ATTACHMENT 1 – Rezoning Review Assessment

Rezoning Review

Figure 1: 24 April Council resolution on the Master Plan for the western side of King Georges Road

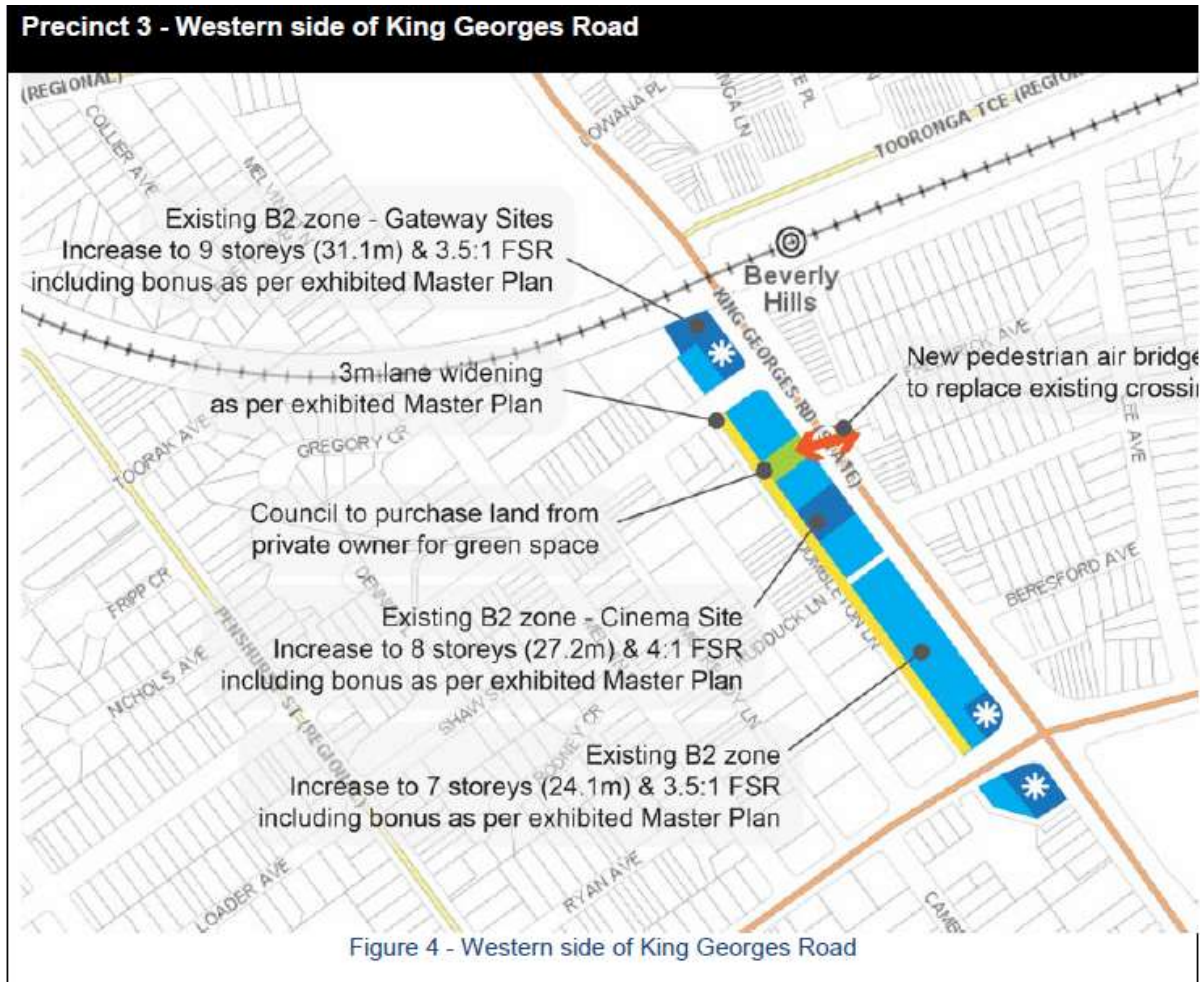
The controls proposed in the 24 April Council resolution for a new Master Plan for the western side of King Georges Road are the same as those proposed in the exhibited Master Plan.

For comparison, **Figure 2** shows the proposed heights and **Figure 3** shows the proposed FSR under the Planning Proposal.
